TECHNICAL BULLETIN

BALLAST WEIGHT INSTALLATION

All MD Helicopters, Inc. (MDHI) MD600N helicopters, RN003 and subsequent.

Tailboom Assembly (P/N 600N3500-503 and -505)

FIGURE 1. Tailboom Ballast Weight Fabrication and Installation.

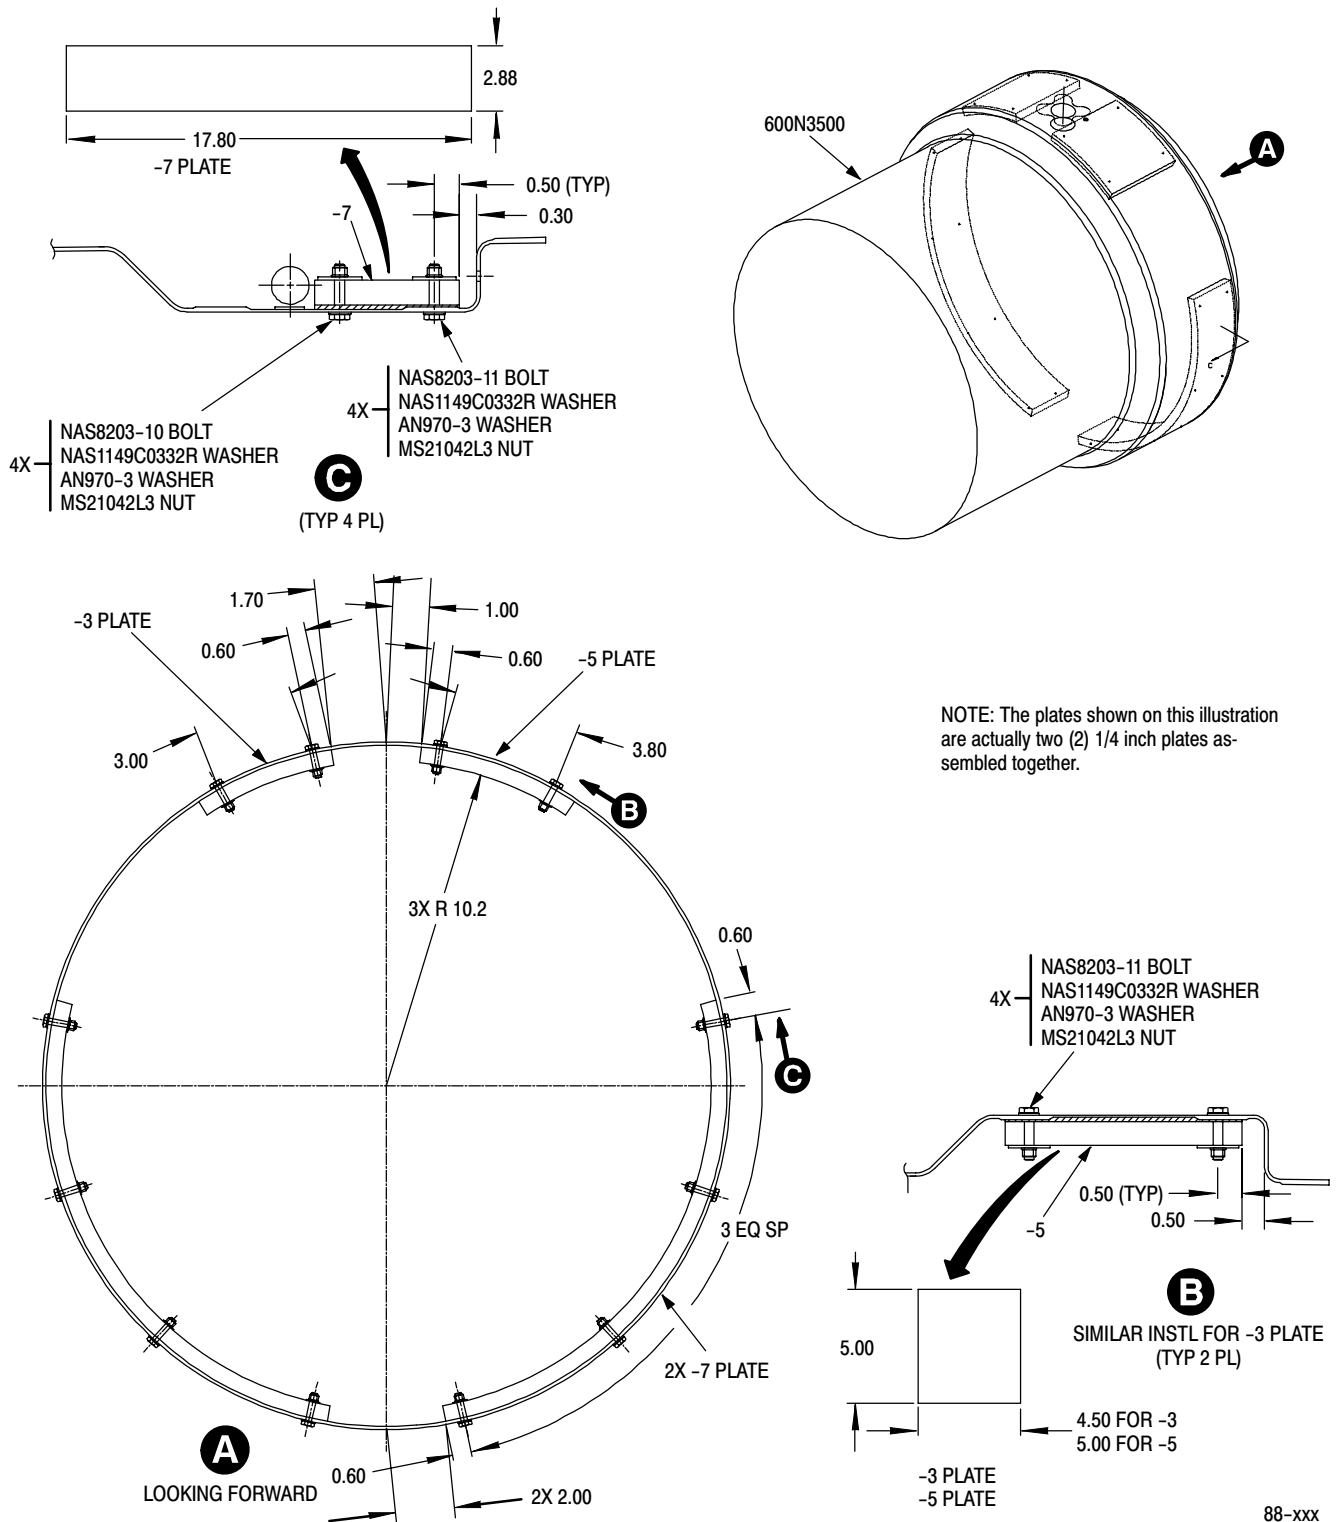
The installation of certain optional equipment may move the aircraft fwd CG out of range. This condition would require the installation of a permanent ballast. This Bulletin provides operators with the option to install ballast weights in the tailboom assembly of their helicopters.

Operators can add 10, 20 or 30 pounds of ballast weight to the tailboom of their helicopter. Procedures in this Bulletin provide owners and operators with information pertaining to fabricating and installing ballast weights in the tailboom assembly. The weights come in three different sizes and are used in various combinations to gain the desired amount of ballast. 10 pounds can be obtained by installing 2 ea. -3 and -5 plates. 20 pounds can be obtained by installing 4 -7 plates only. 30 pounds can be obtained by adding 2 ea. -3 and -5 plates along with 4 -7 plates. Actual weight of plates and hardware will be used to calculate weight and balance.

Refer to Figure 1 and the Handbook of Maintenance Instructions.

- (7). After the lead has been shaped to fit inside the tailboom, drill pilot holes in the lead with a #30 drill bit. Stack the mating plates together (both -3's, -5's and/or -7's) before drilling in order to get holes to align. Refer to Figure 1 for edge distances.

- (13). Install each pair of -3 and -5 coated plates with 4 ea. NAS6203-11 bolts, 4 ea. NAS1149C0332R washers, 4 ea. AN970-3 washers (against lead) and 4 ea. MS21042L3 nuts. Install both pair of -7 coated plates with 4 ea. NAS6203-11 bolts (aft side of plate) and 4 ea. NAS6203-10 bolts (forward side of plate) along with 8 ea. NAS1149C0332R washers, 8 ea. AN970-3 washers (against lead) and 8 ea. MS21042L3 nuts. Torque hardware 12 - 15 inch pounds plus drag torque (maximum).
- (14). Reinstall liner. Skip bond a 1.00 x 1.00 inch area every 2.0 inches maximum with EA9309.3 adhesive. Hold inboard edge of liner with an inflated 650/700 x 10 inner tube. Outboard edge can be held in place using edge sheet metal clamps. Remove inner tube and clamps after 24 hours of cure time.
